Project No. 16074
March 10, 2021

**Subject: Response to Comments From Technical Advisory Committee
Woodbury Cooperative Site Improvements**

WOODBURY COOPERATIVE

SITE IMPROVEMENTS

WATER SERVICE CONNECTION

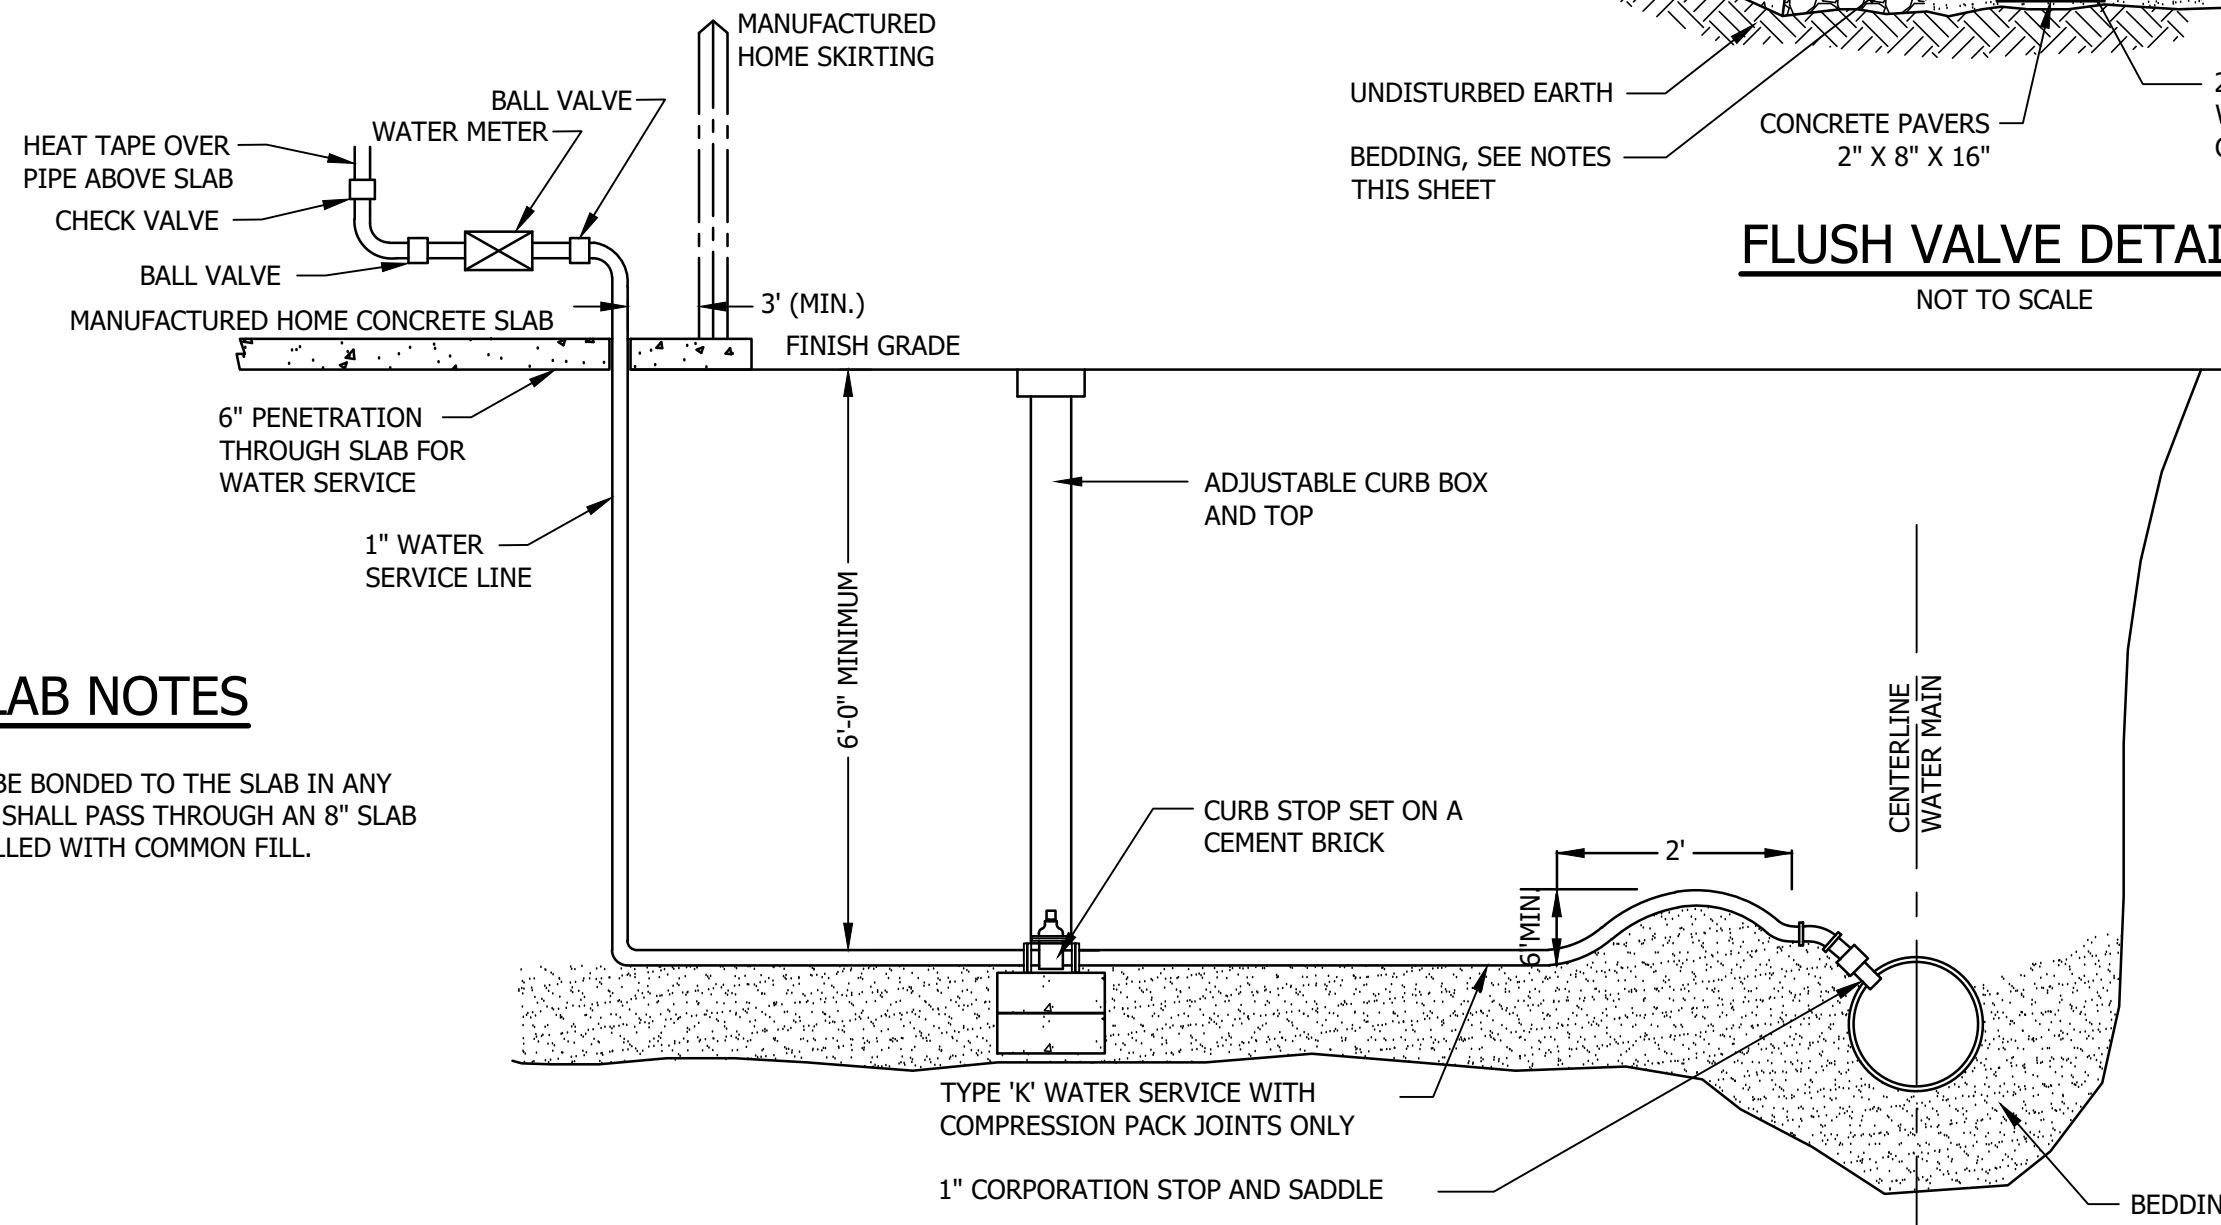
- 13. There needs to be a ball valve both before and after the water meter.**

- 14. Water services to homes must be 1" or larger.**

This change has been made on Sheet 5.

This change has been noted on Sheet 5.

SEWER SERVICE DETAIL

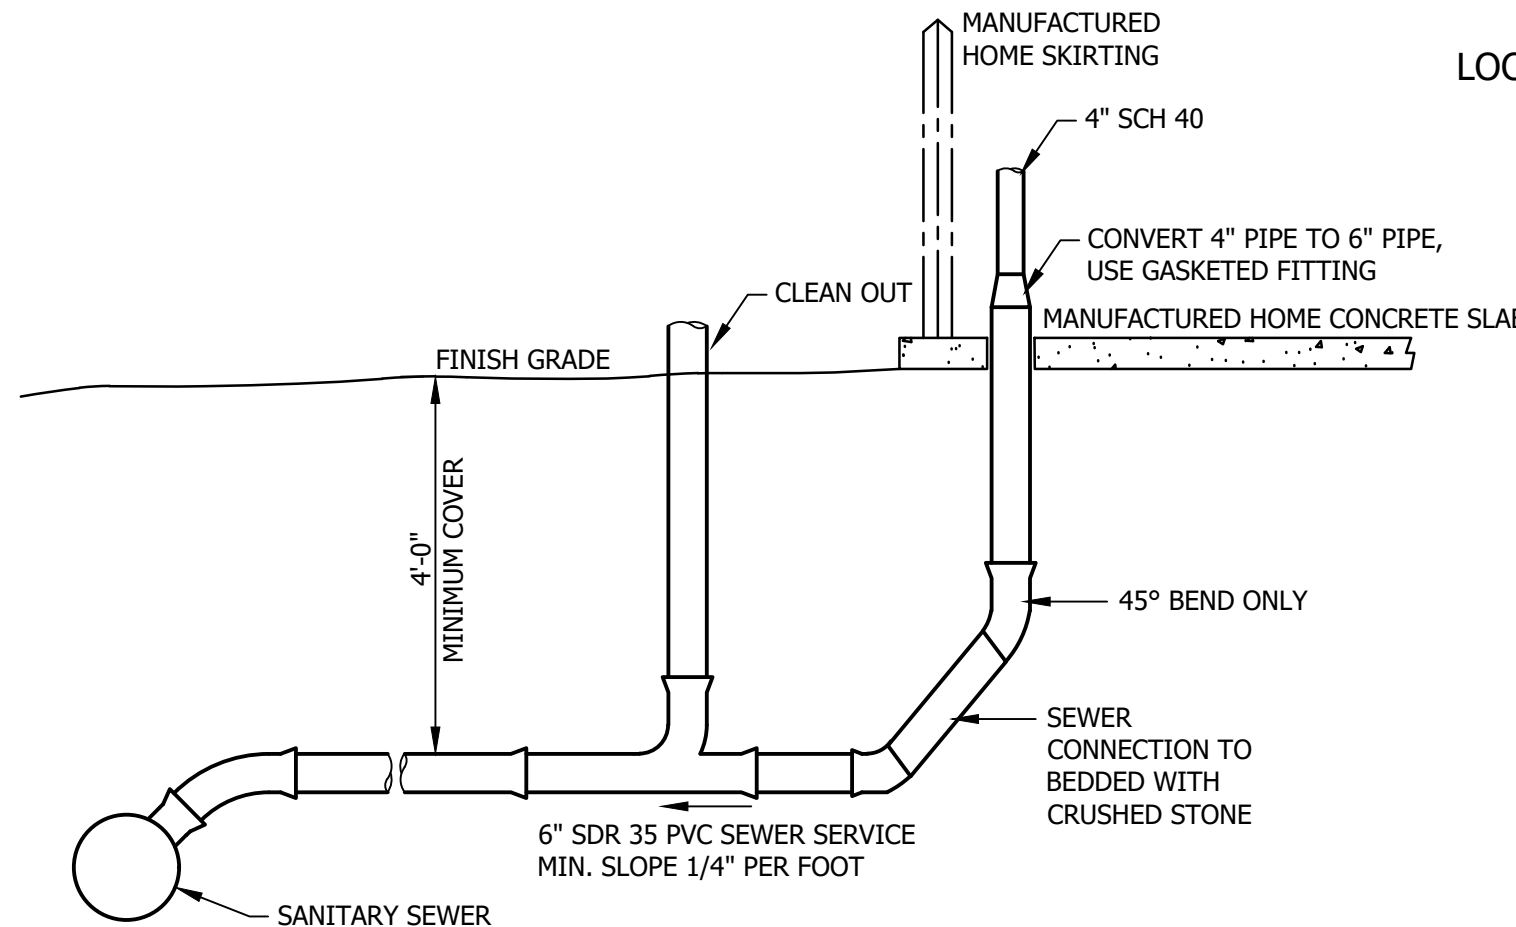
- 12. It is still not clear in the sewer service detail that the concrete slab is not bonded to the sewer lateral. This must be shown properly. The 6" sewer should come through an 8" hole in the slab.**

Notation has been added to notes on Sheet 5.

- THE SEWER PIPE SHALL NOT BE BONDED TO THE SLAB IN ANY WAY. THE 6" SEWER SERVICE SHALL PASS THROUGH AN 8" SLAB PENETRATION AND BE BACKFILLED WITH COMMON FILL.

TYPICAL STOP SIGN
 NOT TO SCALE

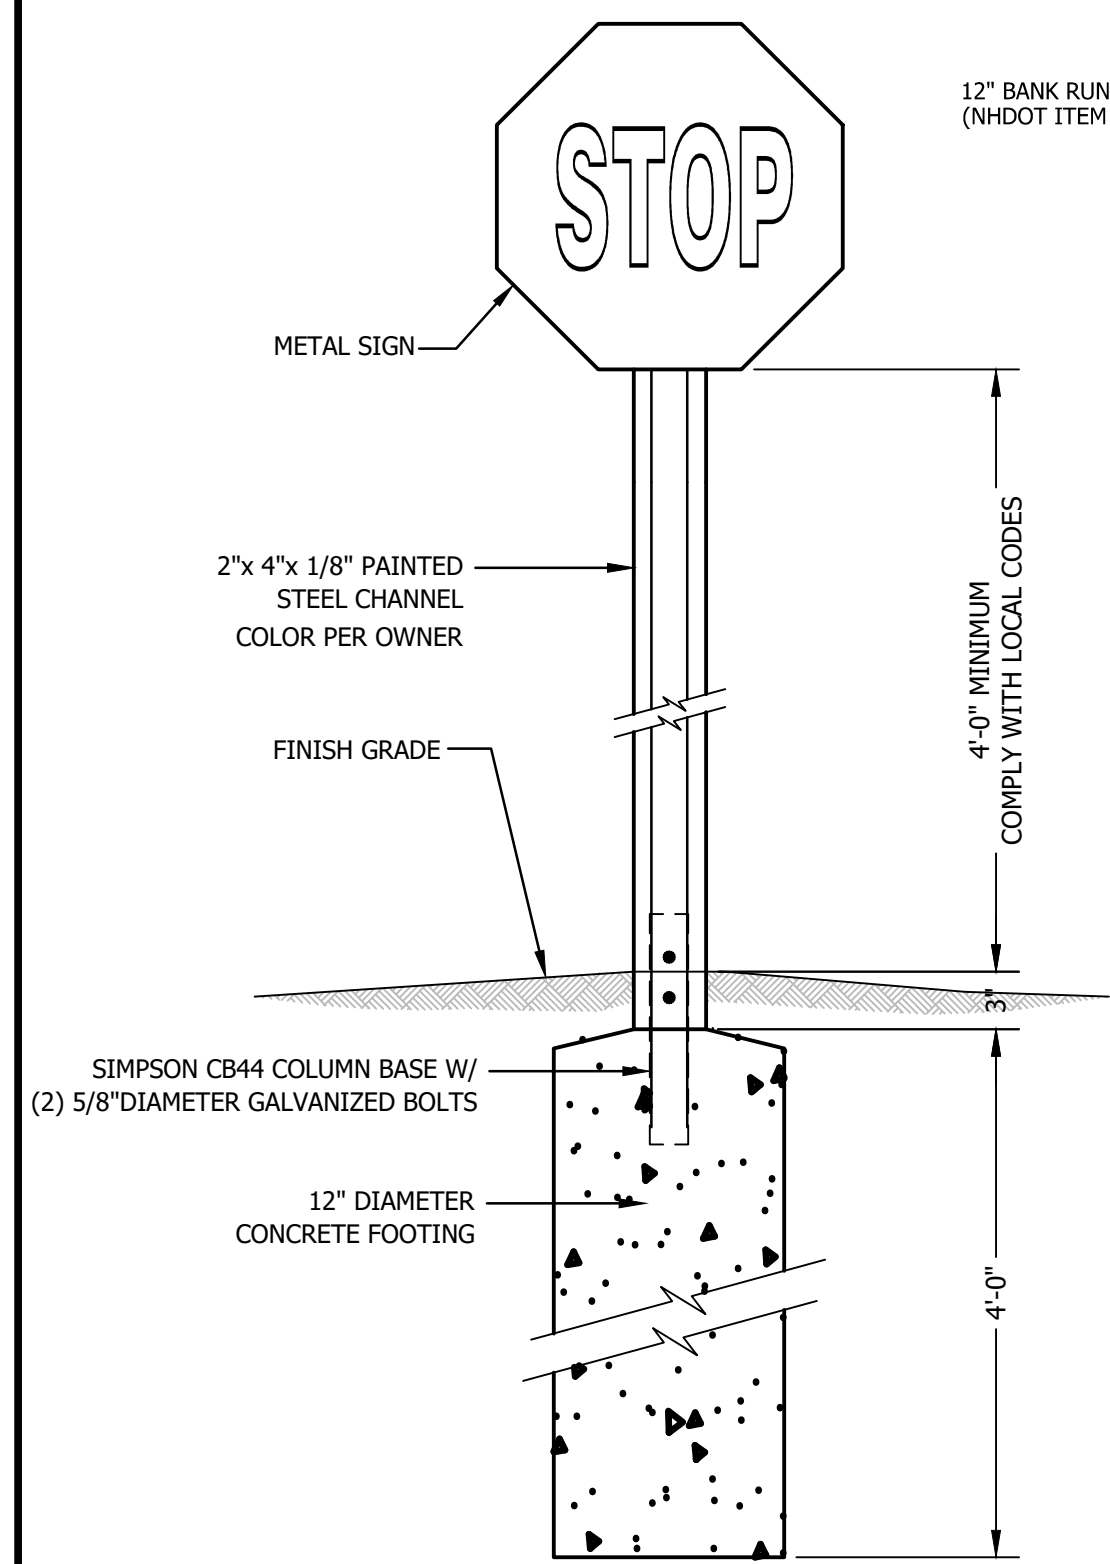
- 2. A stop sign and stop line should be provided on the driveway approach to Woodbury Ave.**

We agree with this comment. The changes have been made to the site plan (Sheet 3) and a detail has been added to Sheet 8.
